Comment Set C29 Donald G. Begalke

Comments on the Draft Environmental Impact Report/Environmental Impact Statement on the Southern California Edison Company's Application for a proposed Devers-Palo Verde No.2 500kV Transmission Line Project:

Responses to Comment Set C29

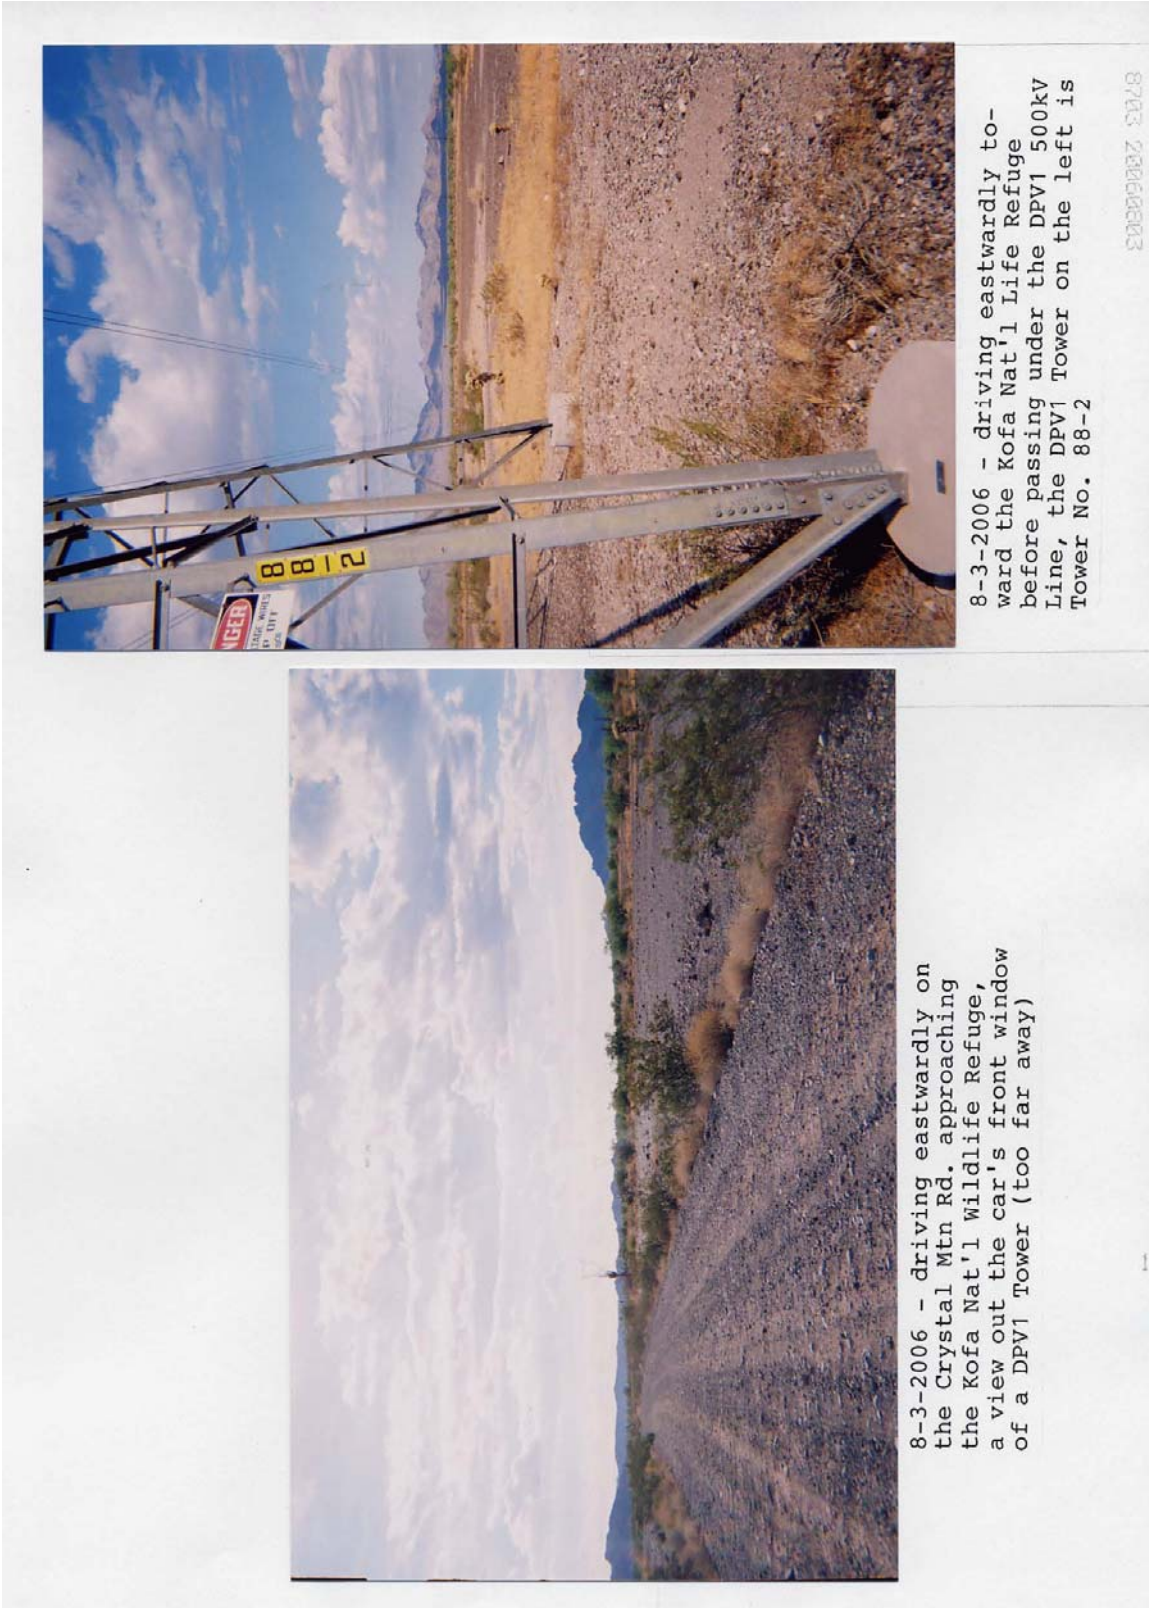
8-3-2006 - driving south on Rt. US95 in Az., a view eastwardly of DVP1 Towers impedes viewing of the Kofa Mtns.

8-3-2006 - the DVP1 Tower, the first, west of US95 in Az. is Tower No. 90-2

C29-36 The photographs provided by the commenter have been noted. Please refer to Response C29-16 and C29-19 regarding the infeasibility of providing photos and simulations at all points along the 300-mile project route.

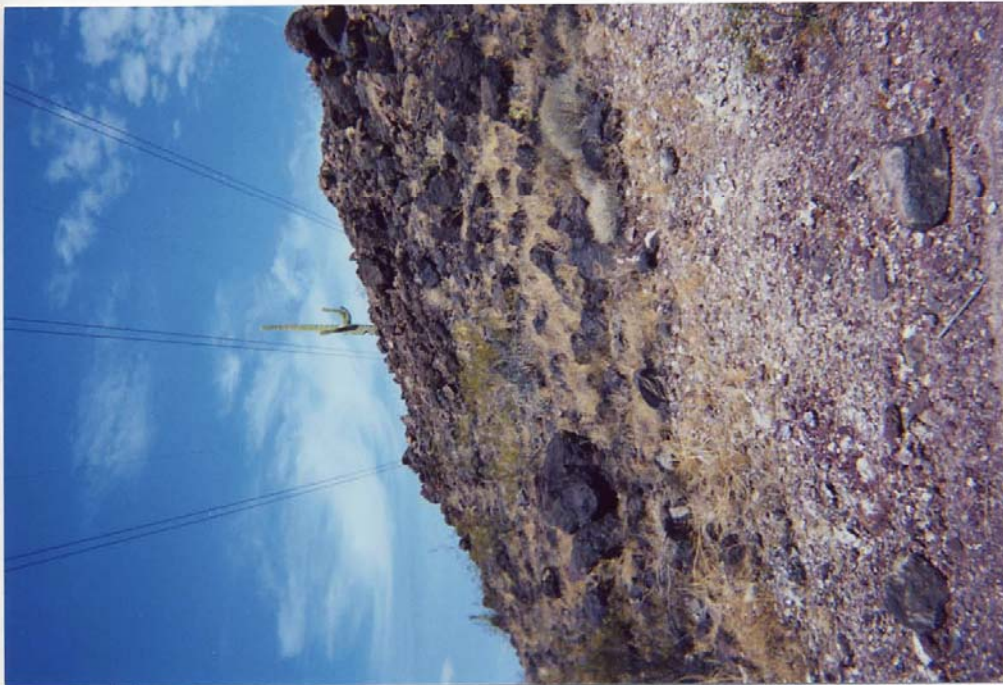
8-3-2006 - by Pipeline Rd. in the Kofa Nat'l Wildlife Refuge (near DPV1 Tower No. 74-1 looking uphill westwardly, a view of DPV1 Towers toward the pass)
